**From:** South East Planning <southeastplanning@cyfoethnaturiolcymru.gov.uk>  
**Sent:** 25 January 2024 14:25  
**To:** Thomas Boothroyd; Planning DC  
**Subject:** P/22/0206 - Vaynor Quarry (Major) V2 - NRW Response NRW:01140459  
**Attachments:** P.22.0206 - Methry vaynor quarry v2.pdf; Abstraction licence response letter.pdf

**BWRIAD / PROPOSAL: FIRST PERIODIC REVIEW OF OLD MINERALS PERMISSION (ROMP) AT VAYNOR QUARRY (PURSUANT TO ENVIRONMENT ACT 1995).**

**LLEOLIAD/LOCATION: VAYNOR QUARRY, UPPER VAYNOR ROAD, CEFN COED, MERTHYR TYDFIL, CF48 2LA.**

## **Application to vary abstraction licence WA/057/0021/0014 Vaynor Quarry**

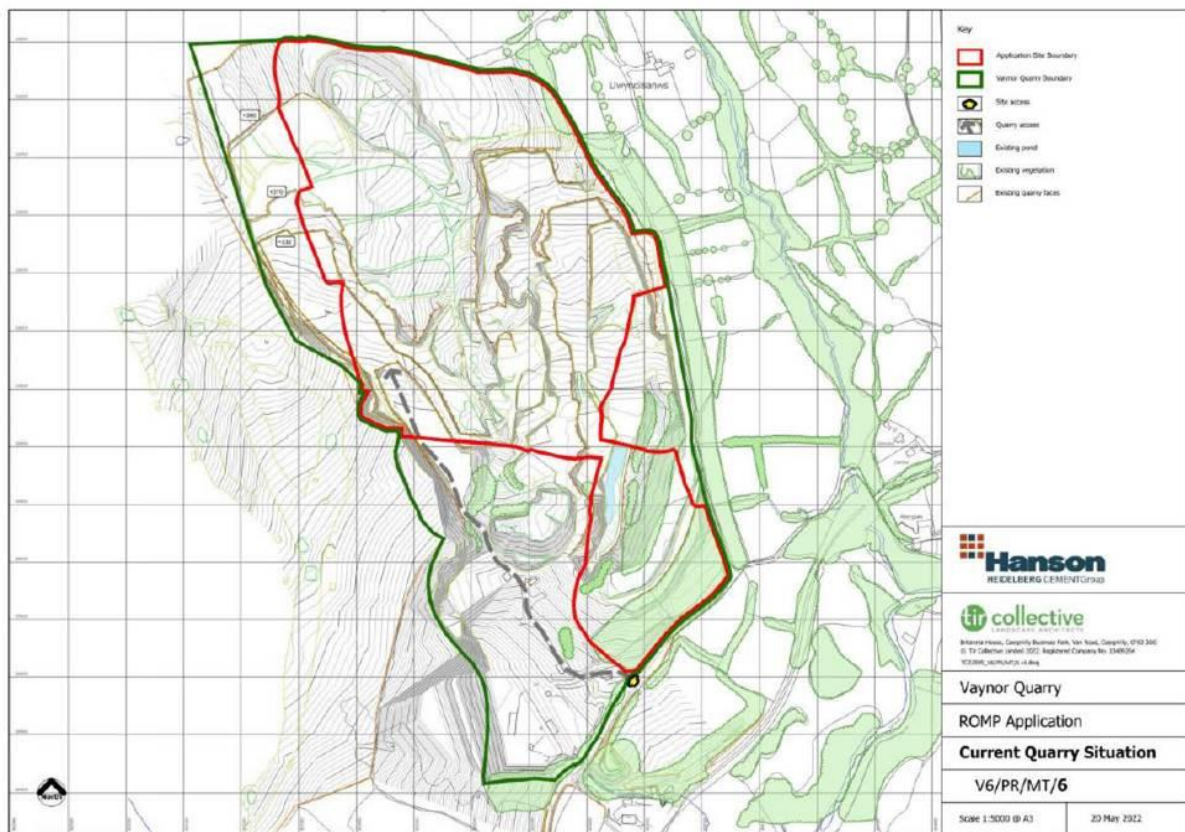
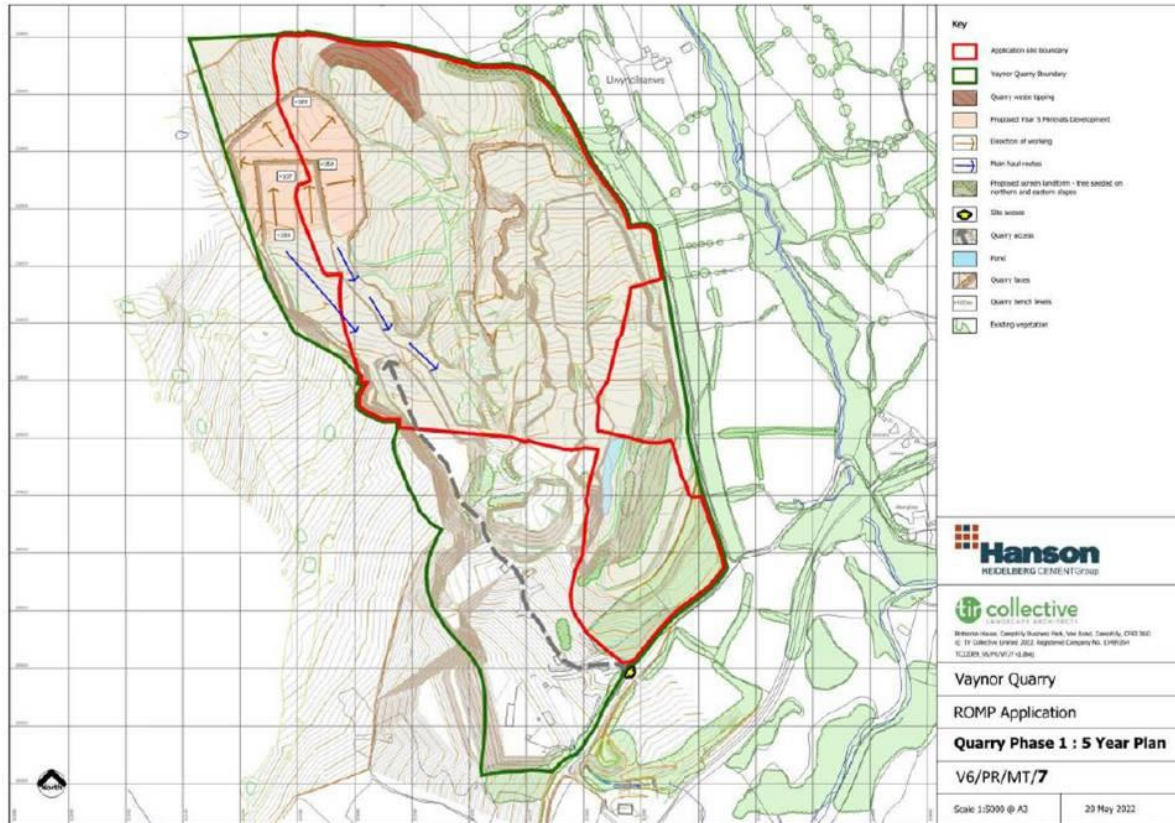
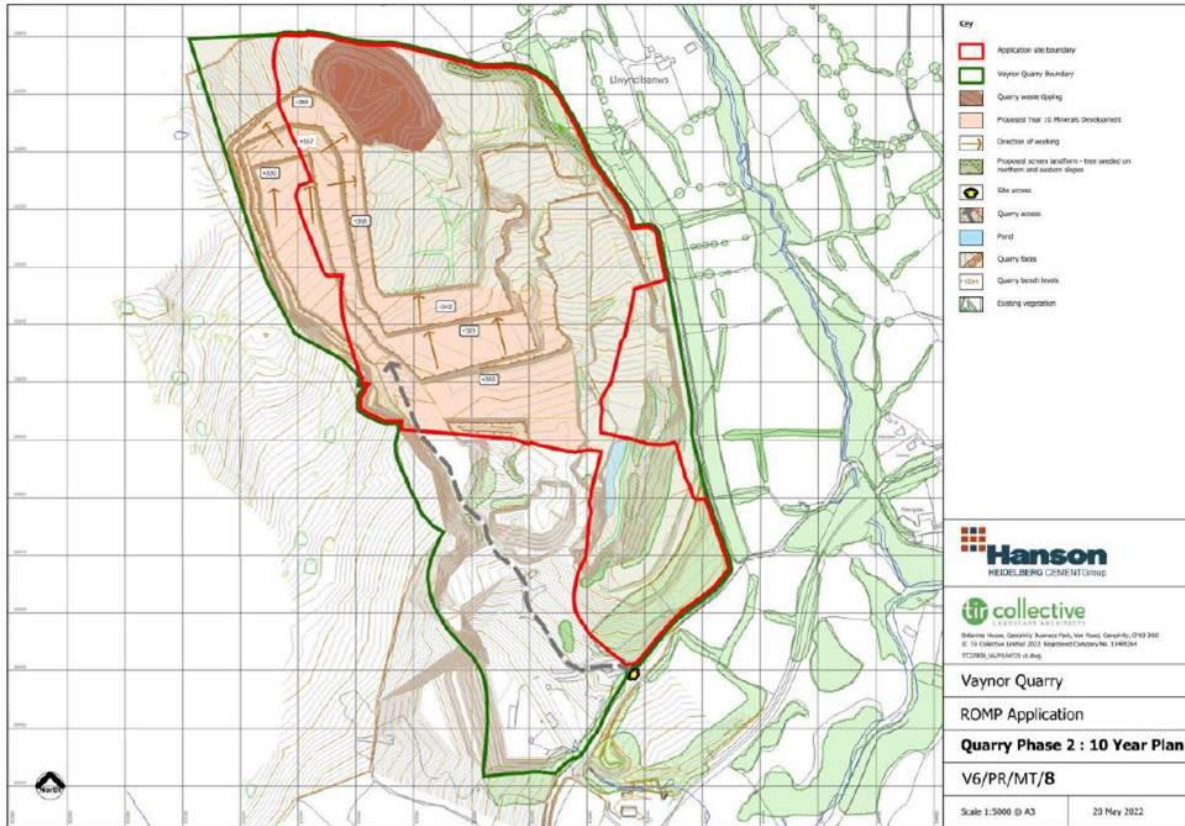
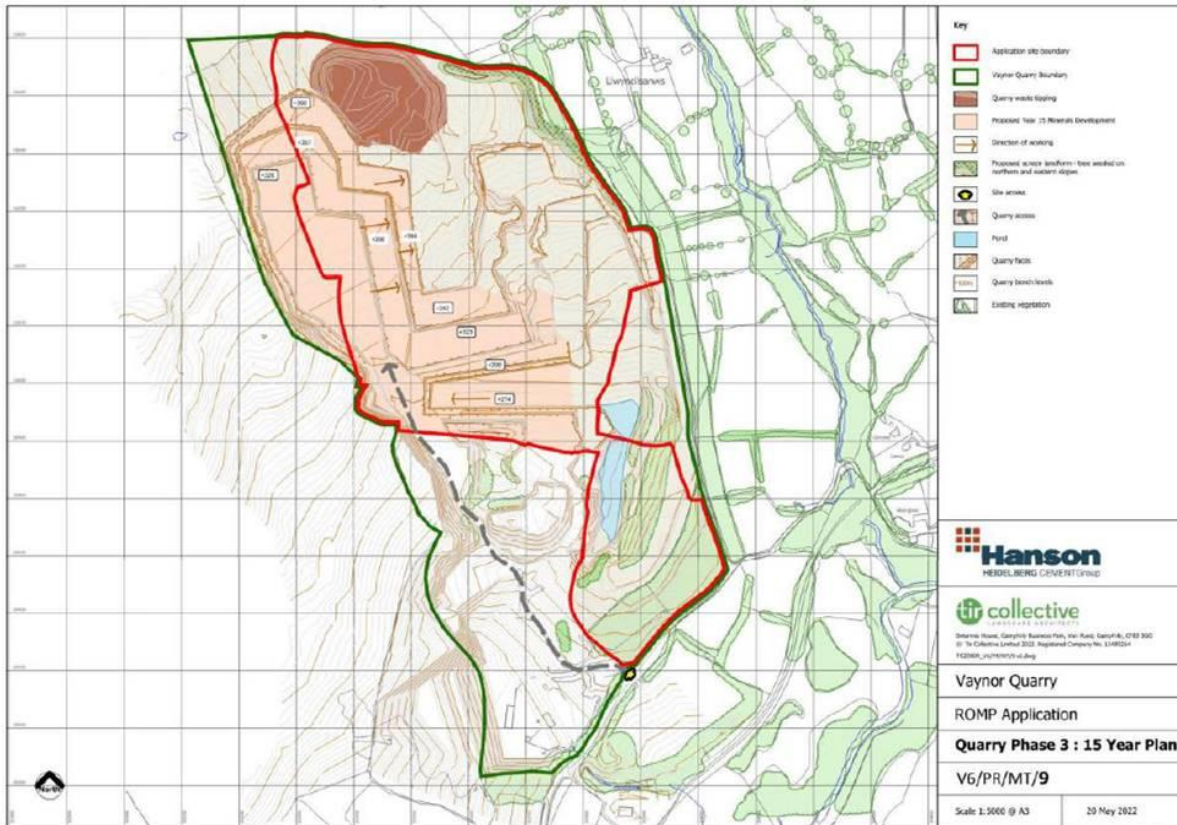
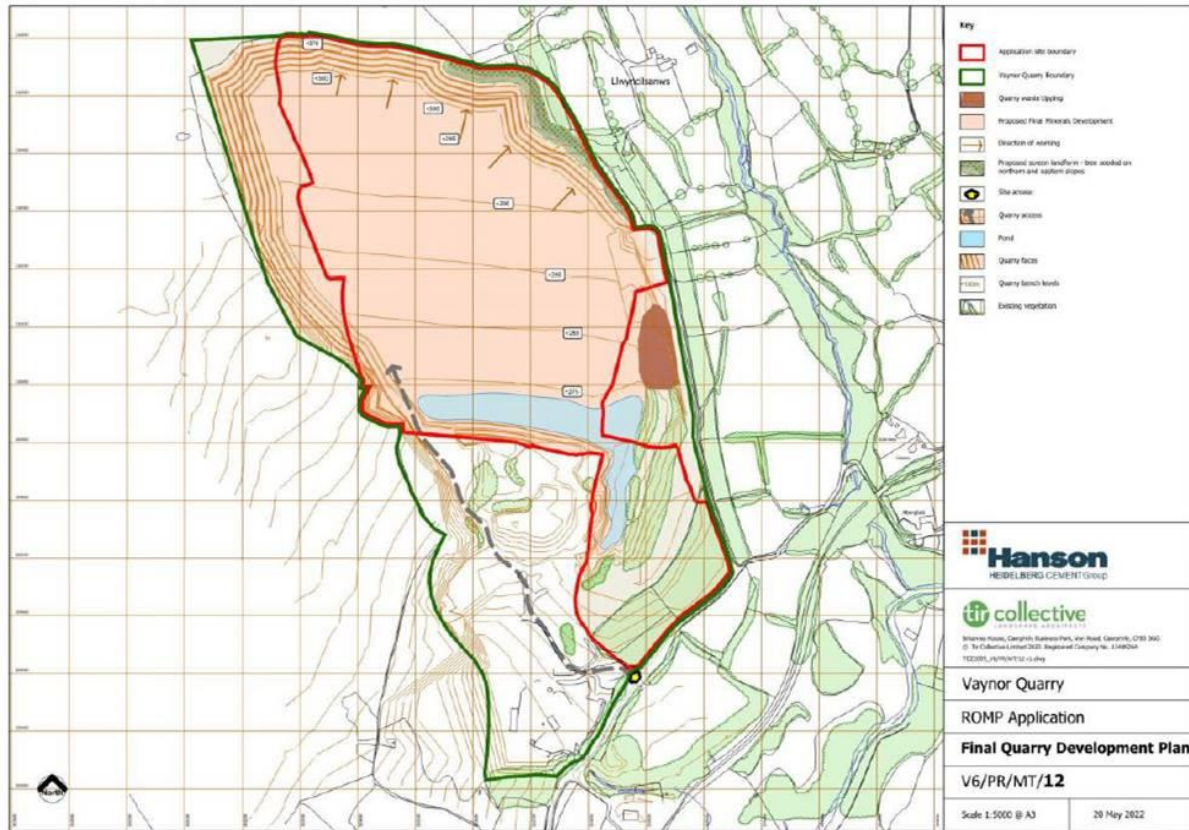
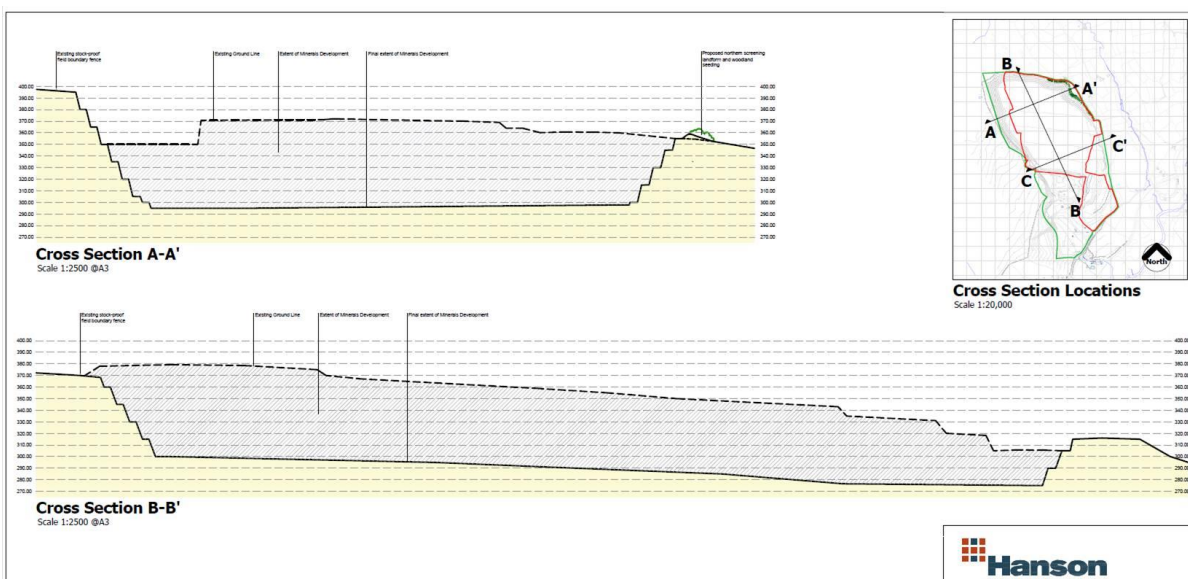
- The numeric model has simulated the SE pond as constant heads. Changes in the spatial characteristics of the pond over time have not been considered.

A review of the proposed phased quarrying excavation is presented in the **ES** as Figures 3-1 to 3-7 inclusive. These Figures show the current pond (light blue feature) within the SE portion of the site generally oriented North-South. After 15 years the pond is depicted as being slightly larger on the northern end of the pond

and then after 30 years a West-East oriented limb to the pond is shown as added which is then widened as part of the restoration phase.

- Simulate the pond in the SE corner of the site so that the simulations reflect changes in the spatial characteristics of the pond over time as the current model relies on one pond footprint. Explore calibration to pond levels.

Figure 2.12 Predicted heads in vicinity of Site in Layer 2: hydraulic conductivity 0.25 m/d

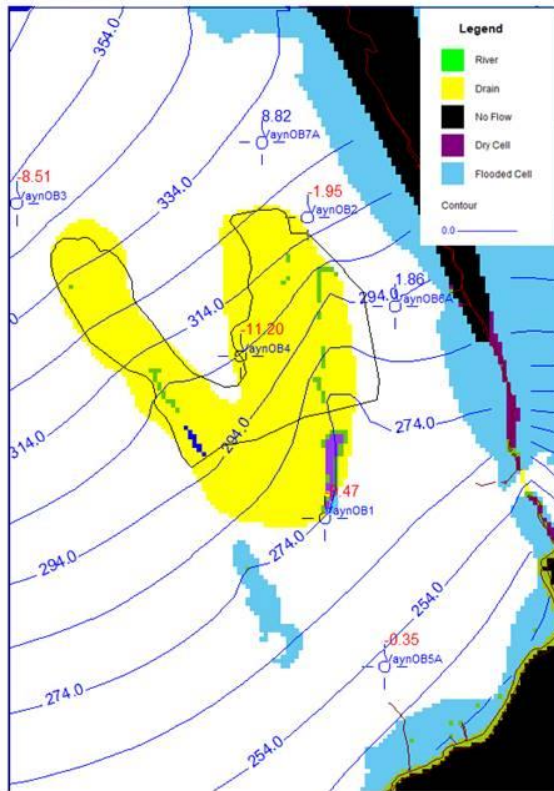
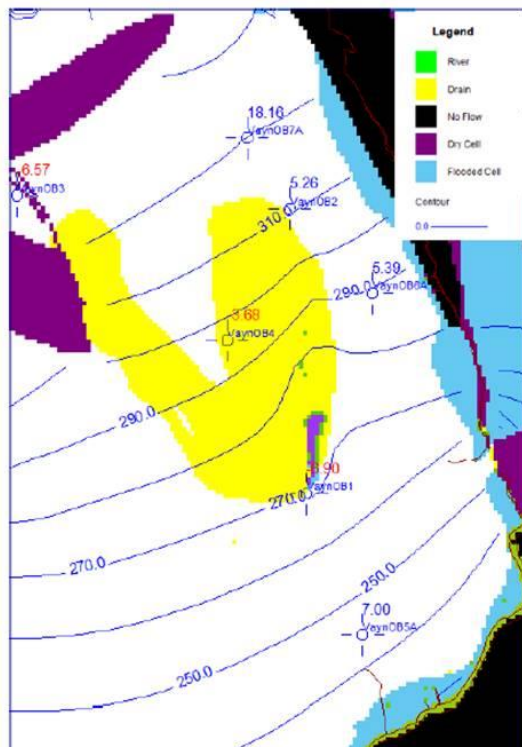
- The hydraulic conductivity values of 0.15m/d and 0.25m/d are not considered representative of fractured limestone. Hydraulic conductivity values representative of limestone fracture systems are generally significantly greater than the values used in the model.

- There are dry cells and flooding cells that have manifested during the numeric modelling exercise which indicate that the model is not a good representation of reality. These manifestations will interfere with model convergence. The model has a central 10 m grid and 5 layers and it does not appear to be representing site conditions very well. This is not surprising given the difficulty of modelling a fractured bedrock system with multiple sinks (springs / rivers) and topography and using inter-granular flow as the flow mechanism.

The following two figures shows the predicted heads using a hydraulic conductivity of 0.15m/d and 0.25m/d respectively. Calibration values to measured groundwater levels at particular wells, for example VaynOB3 to the west, are shown as either a simulated head increase in red or a head decrease in blue. For example, VaynOB5a located to the south shows a simulated head increase of - 8.35m using a hydraulic conductivity of 0.15m/day with a head decrease of +7.00m using a hydraulic conductivity of 0.25m/day. This shows that a simple change to the mass hydraulic conductivity value results in a significant difference in the simulated head values at VaynOB5a compared to actual values. Calibration has therefore not been achieved. Note that groundwater monitoring well VaynOB5a is the closest to the Taf Fechan ecosystem and springs.

- Revisit the nature of the numeric modelling that has been performed to date with an emphasis on assessing future flows and groundwater dynamics using a simulator that can model fracture-flow. This can only be considered successful if a meaningfully calibrated model for current conditions can be developed so that there is more confidence in predicted conditions and hydrodynamics. Calibration should utilise spring, river flow and pond level data. Explore integrating aspects of the FCA such as pond recharge and changes in the pond footprint that are proposed over the coming decades into the numeric groundwater model. Explore whether the pond groundwater system is best simulated using variable recharge or constant heads.

Figure 3.6 Additional drawdown imposed by proposed quarry extension in Layer 2:  
hydraulic conductivity 0.15 m/d

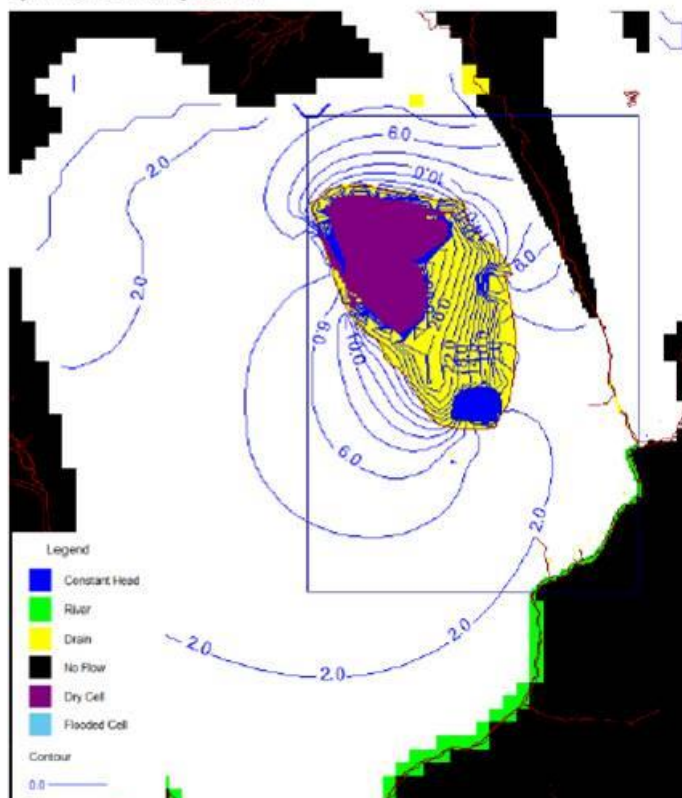
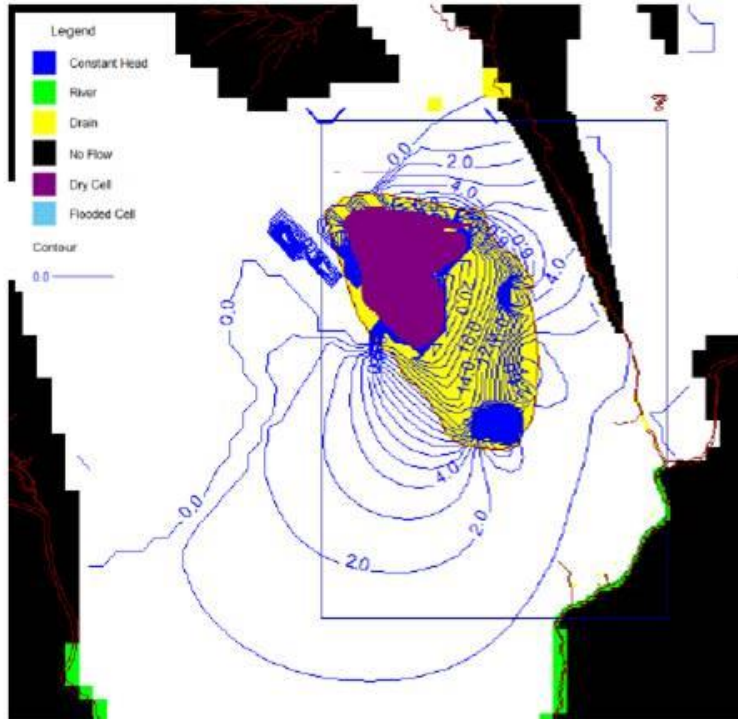
The following two figures shows the additional drawdown using a hydraulic conductivity of 0.15m/d and 0.25m/d respectively. There is a significant difference in the magnitude of the estimated drawdown to the east and northeast. The large blue area within the southern area is the pond and this has been simulated as a constant head which therefore controls the nature of the simulated groundwater drawdown contours around it and within the southern area of the site. Contouring within fractured rock systems must be treated with caution as such contouring are representative of equipotential lines which may not representative of fractured rock systems.

Figure 6.2 Runoff catchments – current

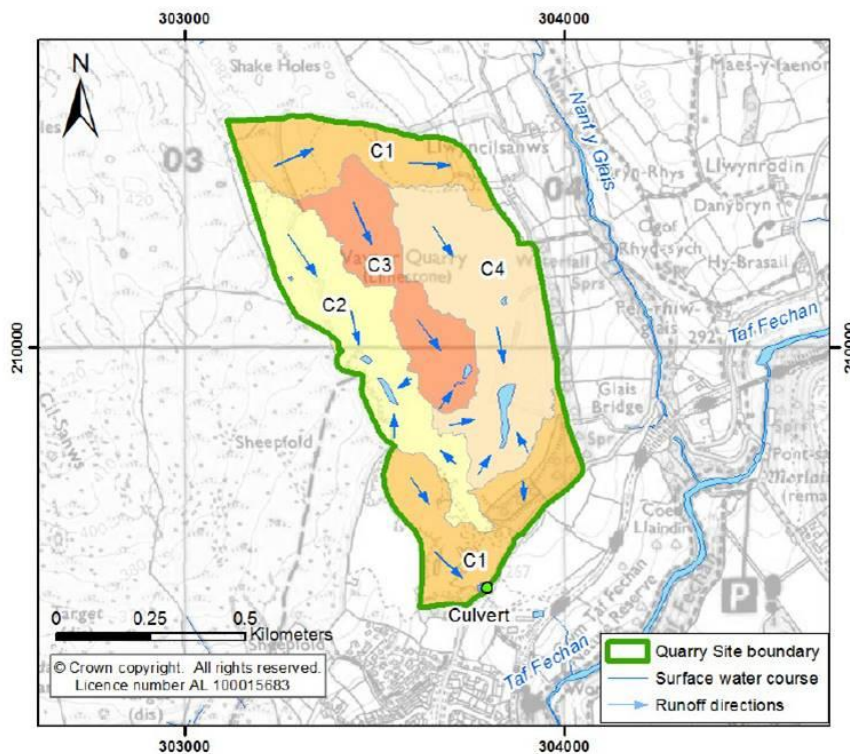
Page 37 of the **Vaynor Quarry: Flood Consequence Assessment (FCA) and Drainage Strategy, August 2022** depicts the current runoff catchments at the site. It is unclear if or how these were considered as part of the numeric groundwater modelling exercise.
